U.S. NUCLEAR REGULATORY COMMISSION  
REGION IV

Report No.: 50-313/96-06; 50-368/96-06

Facility: Arkansas Nuclear One, Units 1 and 2

Dates: August 18 through September 28, 1996

## GENERAL REFERENCE POINTS

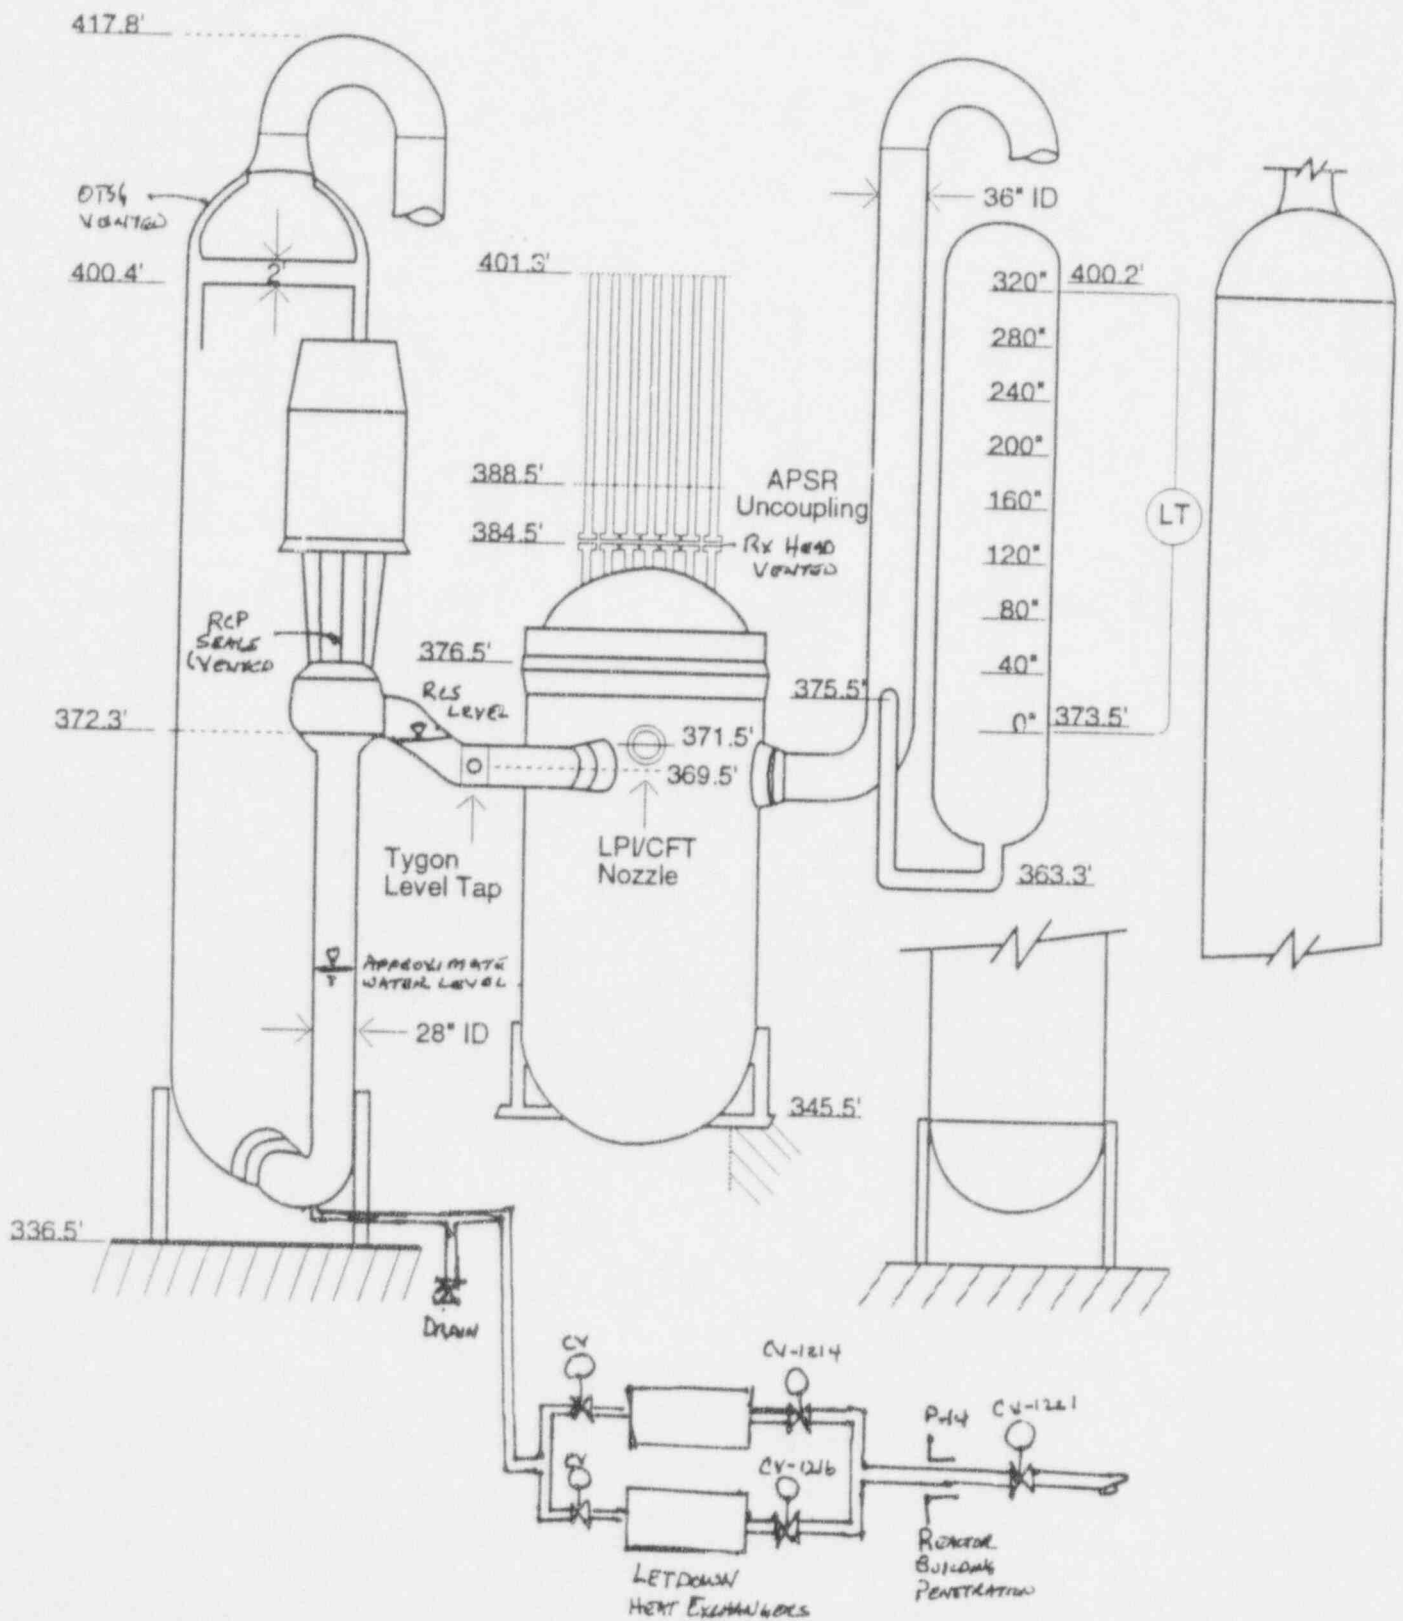
A sketch of the system is included in Attachment 2. The RCS consists of the reactor vessel, two vertical OTSGs, four RCPs, a pressurizer, and interconnecting piping. In each heat transport loop, there is a hot leg pipe connecting the reactor vessel to the top of each OTSG, piping from the bottom of OTSG to the RCPs bowl, then piping from the RCP to the reactor vessel. The piping from the bottom of the OTSG rises approximately 35 feet to the suction of the RCPs. There is a connection on this line to the letdown system. There are four cold legs and two hot legs which penetrate the reactor vessel at the same elevation. The RCP bowl elevation is 372.3 feet.

The RCS was in reduced inventory with a stable level indication of 371.5 feet. The licensee was draining the cold legs in preparation to install nozzle dams on the OTSGs, but the water was not entirely drained and the water level was above the OTSG bowl. The drainage path from the cold legs used a drain off of the normal letdown line. The RCP seal vents, reactor vessel head, and OTSG were opened.

The inspectors found, because of the configuration of the RCS, that the maximum RCS level increase would have been limited to approximately 0.7 feet. Beyond that indicated level, additional venting capacity would have been available. For this occurrence, the decay heat removal (DHR) capability was not reduced. In assessing the amount of water which would have to be removed before DHR would be lost, the inspectors found that accurate level would have been restored before losing a DHR pump. The licensee planned to revise procedures to add a caution regarding the use of air in this plant configuration. At the end of the inspection period, the licensee had not completed their root cause determination.
